Access Compliance Report

Public Rights-of-Way

Intersection ID: 15599	Main Street: COLVILLE_RD	Cross Street: EASTOVER_RD	Location: SE
ADA ID: 17AC65503596	Ramp Type: Perp	Initial Pass/Fail: Fail	Overall Compliance: No
Codes/Mitigation Info/Possible Solution		Field Measurements/Component Compliance	
Severity Score: 26.25

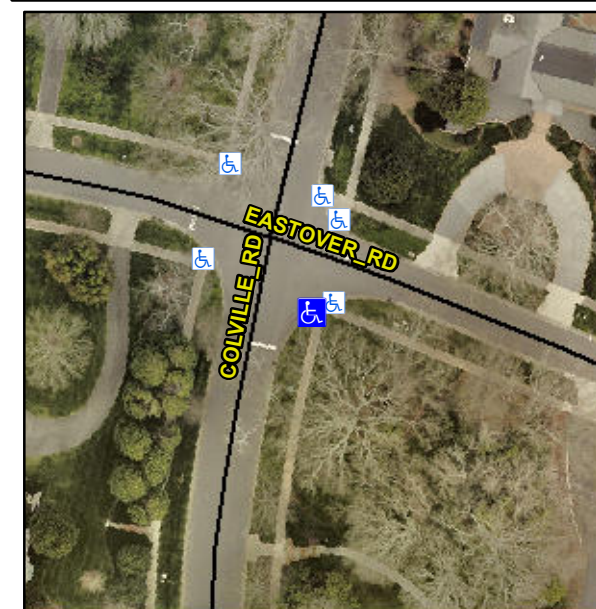
Not Found, R304.2.2, R304.5.3

Compliance	Description	Data	Compliance	Description	Data
N/A	Ramp Length (in)	48.0	No	Ramp Slope (%)	15.8
Yes	Ramp Width (in)	48.0	No	Ramp XSlope (%)	4.9
N/A	Flare Type LT	N/A	N/A	Flare Type RT	N/A
N/A	Flare Slope LT (%)	N/A	N/A	Flare Slope RT (%)	N/A
N/A	Flare Traversable LT?	N/A	N/A	Flare Traversable RT?	N/A
N/A	Landing Length (in)	N/A	N/A	DWS Provided?	N/A
N/A	Landing Width (in)	N/A	N/A	DWS Contrast?	N/A
N/A	Landing Slope (%)	N/A	N/A	DWS Length (in)	N/A
N/A	Landing X Slope (%)	N/A	N/A	DWS Full Width?	N/A
N/A	Landing Curb? (Y/N)	N/A	N/A	DWS Offset (in)	N/A
N/A	Shared Landing?	N/A			
N/A	Gutter Ponding?	N/A	N/A	Gutter Slope (%)	N/A
N/A	Gutter Lip Ht (in)	N/A	N/A	Gutter X Slope (%)	N/A
N/A	Painted X Walk1?	No	N/A	Painted X Walk2?	N/A
	X Walk 1 Direction	To NW		X Walk 2 Direction	N/A
N/A	X Walk 1 Width (in)	N/A	N/A	X Walk 2 Width (in)	N/A
	X Walk 1 Slope (%)	5.3		X Walk 2 Slope (%)	N/A
	X Walk 1 X Slope (%)	0.5		X Walk 2 X Slope (%)	N/A

Remove & Replace Entire Ramp.
